**Siccar Point Energy E&P Limited
Cambo Field Development**

Cambo Environmental Statement (D-4240-2019)

Additional Information Requested by BEIS under Regulation
10(2) of the Offshore EIA Regulations

Figure 13.6: Well Blow-out Modelling: Arrival Time Plot

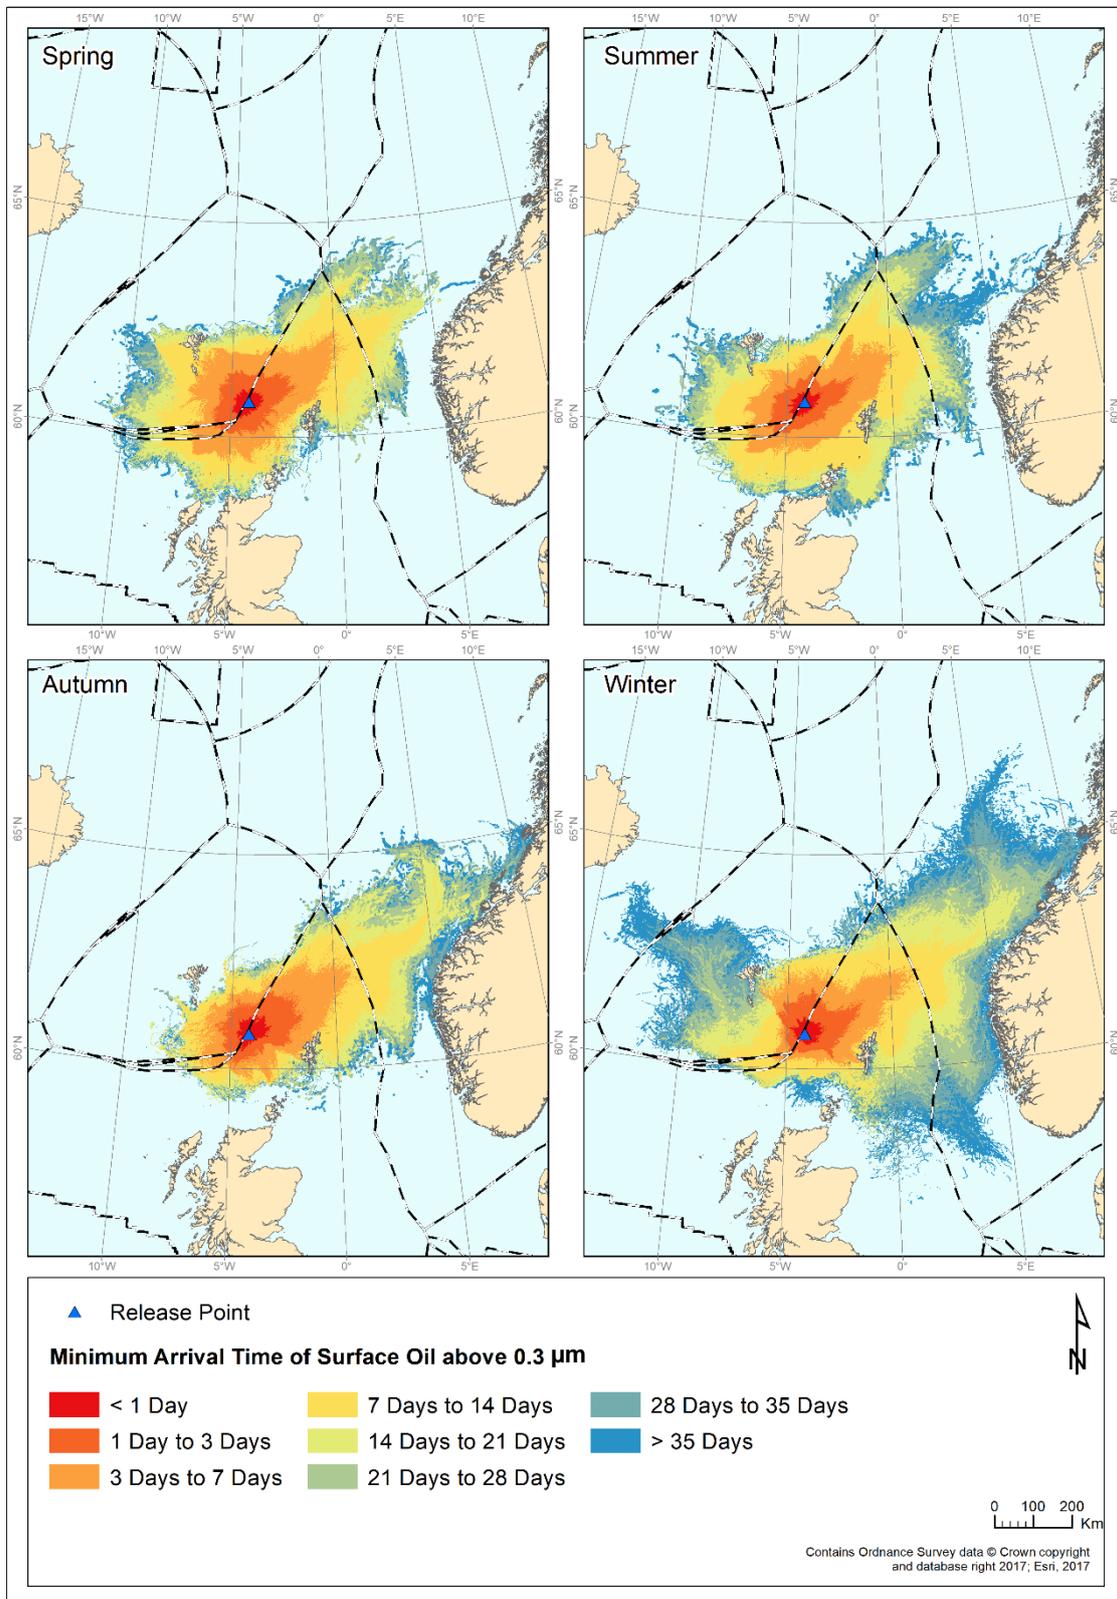
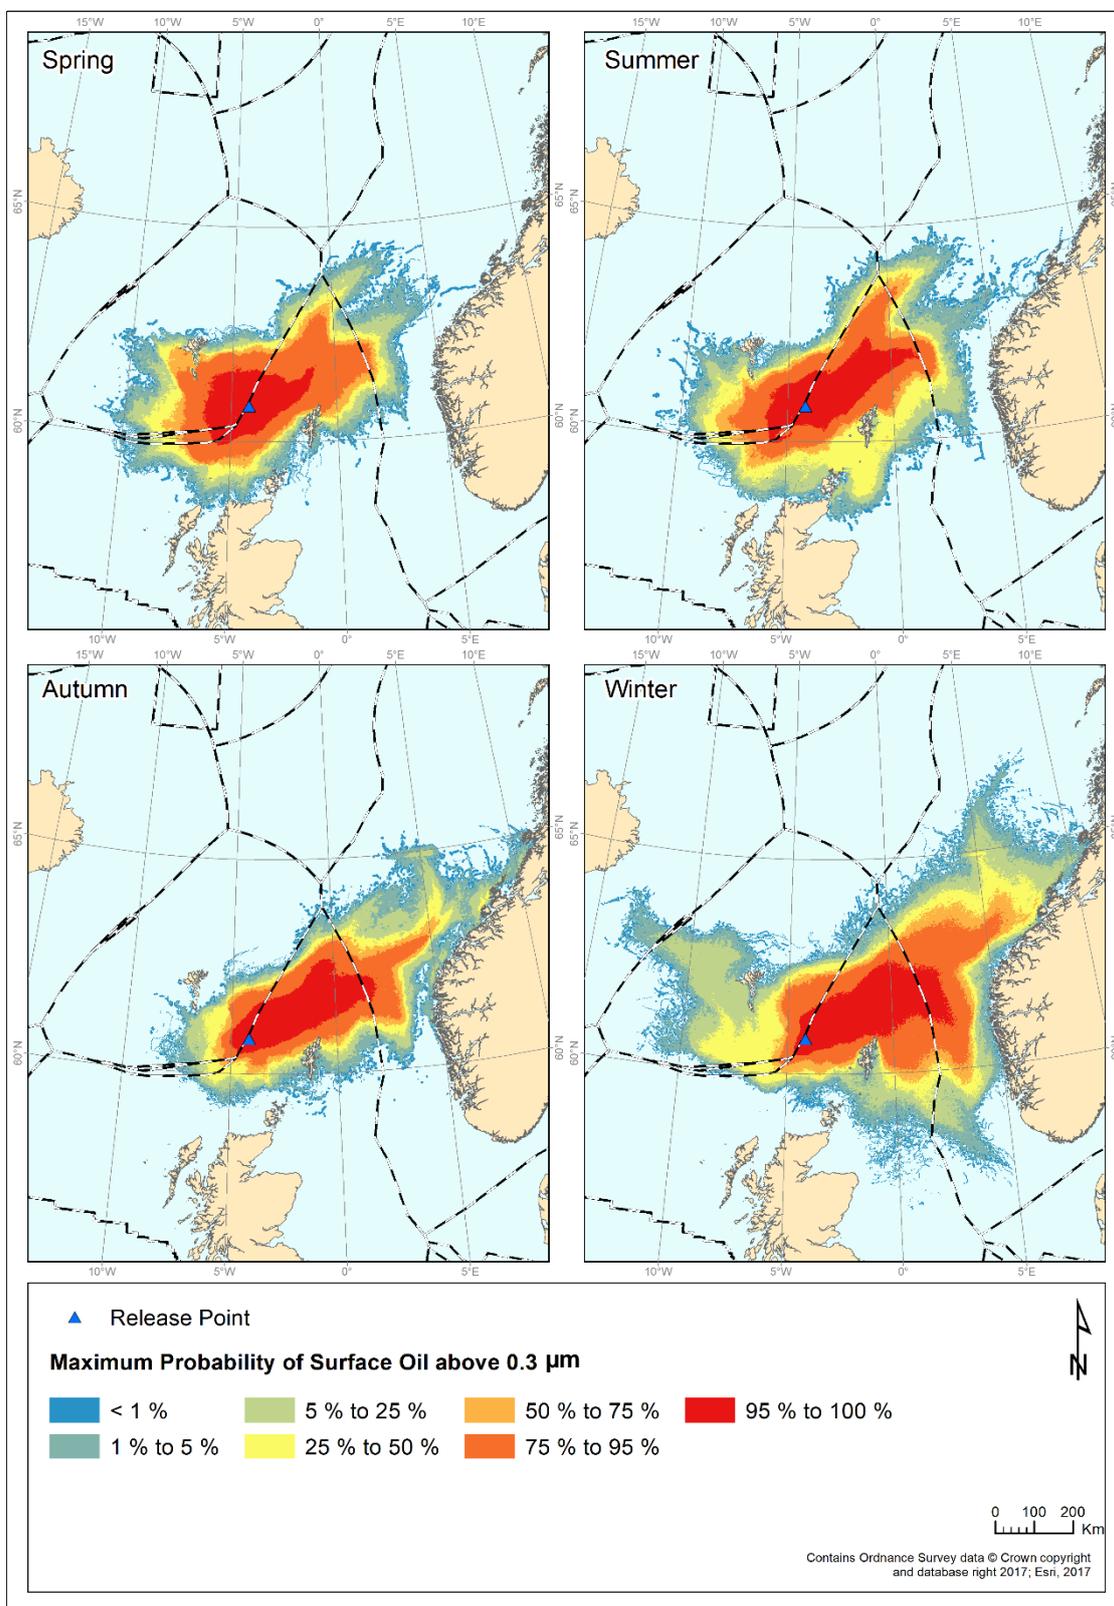
OPRED Ref:	75	ES Section:	Section 13.4.3 – Page 13-8 – Oil Spill Modelling
OPRED Comment: (01/02/2020)	The uncontrolled well blow out modelling has been undertaken utilising flow data for a well P4 which is no longer included in the current well plan but is considered representative of the actual wells to be drilled. To support this position please clarify the flow rate of the highest flow well in the current well plan.		
Additional Information Provided by SPE:	<p><i>The flow rates of the highest flow well in the current well plan are:</i></p> <ul style="list-style-type: none"> • <i>Day 0 to 5: 5,239 m³</i> • <i>Day 6 to 10: 3,806 m³</i> • <i>Day 11 to 20: 3,356 m³</i> • <i>Day 21 to 30: 3,117 m³</i> <p><i>Oil Spill Modelling using these flow rates has been undertaken. Section 13 - Accidental Events of the Cambo ES has been updated accordingly (see attached updated ES Section 13).</i></p>

Figure 13.8: Vertical Movement of Cambo Crude Oil Plume

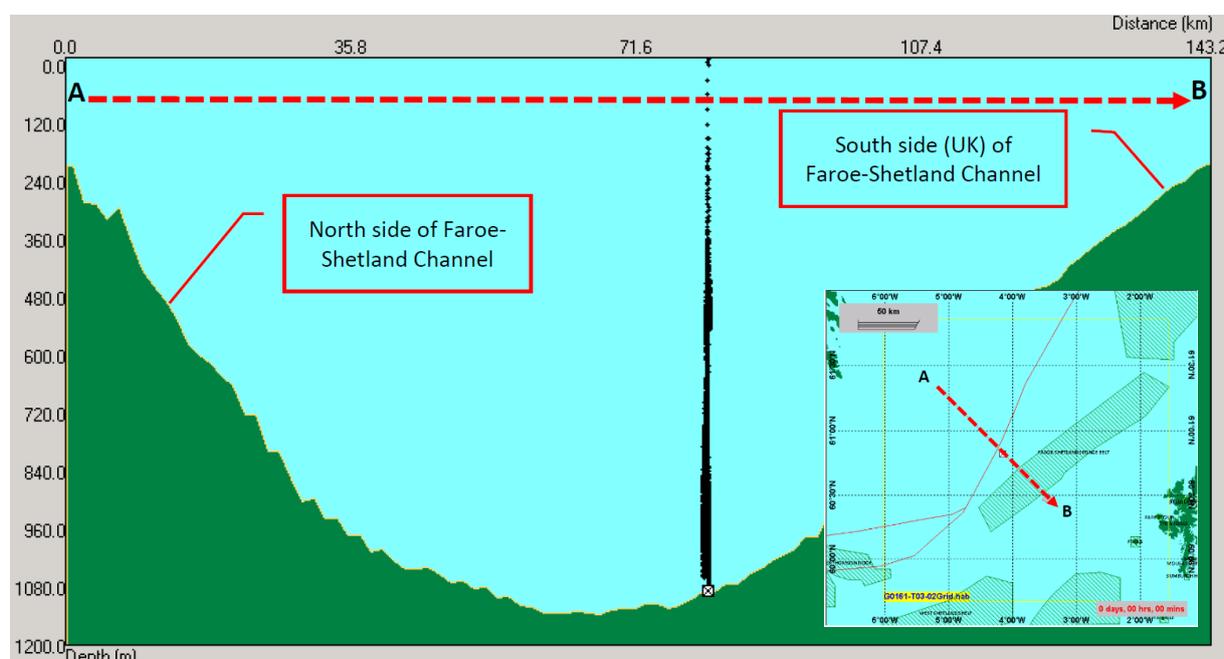
OPRED Ref:	77	ES Section:	Table 13.1 – Page 13-9 – Well Blow-out Modelling Parameters
OPRED Comment: (01/02/2020)	Please clarify whether the current regime in the area has been taken into account for modelling purposes i.e. direction of water flow at various depths. If a vertical profile model of the release has been undertaken, please provide this.		
Additional Information Provided by SPE:	<p><i>Yes, SPE confirms that the OSCAR model takes account of different current speed and direction throughout the water column. A vertical profile model of the release was undertaken and has been attached for reference. The vertical plume modelling shows that the oil plume is expected to rise up through the water column to the sea surface in approximately 2.5 hours, whereas the gas plume does not reach the surface and is absorbed into the water column. As the small oil droplets encounter the thermocline at ~400 m below sea surface the rise speed slows and some of the smaller droplets are halted. Although not shown in the model, it is most likely that any potential sub-surface oil plume would get trapped at this depth. At this depth, any trapped oil is likely to be driven by the Faroe-Shetland slope current, that generally flows towards the northeast (towards Norway) all year around.</i></p>
